Land-Rover Service Newsletter Vol. 3 No. 13

June 1970

The Rover Company Limited Service Department: Solihull, Warwickshire, England

Fig. 1. Spring identification

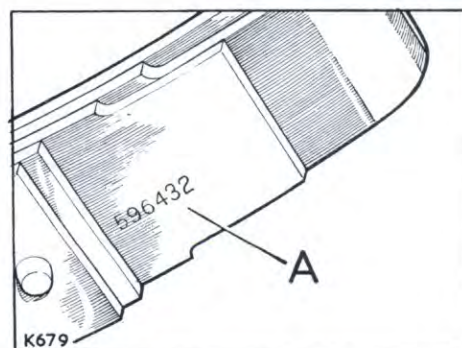
1. Check the part numbers to ensure that the correct springs are fitted. The Part No. is stencilled on the top face and stamped on the under face of one of the leaves. See Fig. 1 below.
